Office Action Summary

10/781,484

ZUBOK ET AL.

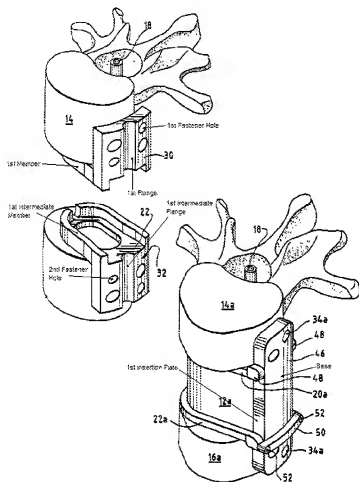
6. Claim 1 is rejected under 35 U.S.C. 102(b) as being anticipated by Songer (U.S. Patent 6,395,030).

Songer discloses a device comprising a first member, a first intermediate member, and a first insertion plate (see Figure 1 below). The first member includes a first vertebral contact surface and a first flange including a first through hole capable of receiving a bone screw and a first fastener hole. The first intermediate member includes a first intermediate vertebral contact surface capable of contacting an endplate of an intermediate vertebral bone adjacent to the first vertebral bone and a first intermediate flange entirely offset to one side of a spinal midline, i.e. the superior side, including a second fastener hole offset from the first fastener hole of the first member. The first insertion plate is capable of engaging the first member and the first intermediate member, wherein the first fastener hole and the second fastener hole are sized and positioned to receive at least one fastener to couple the first insertion plate to the first member and the first intermediate member, wherein the first insertion plate is capable of orienting the first member and the first intermediate member for simultaneous insertion

into an intervertebral disc space defined by the first vertebral bone and the first intermediate vertebral bone.
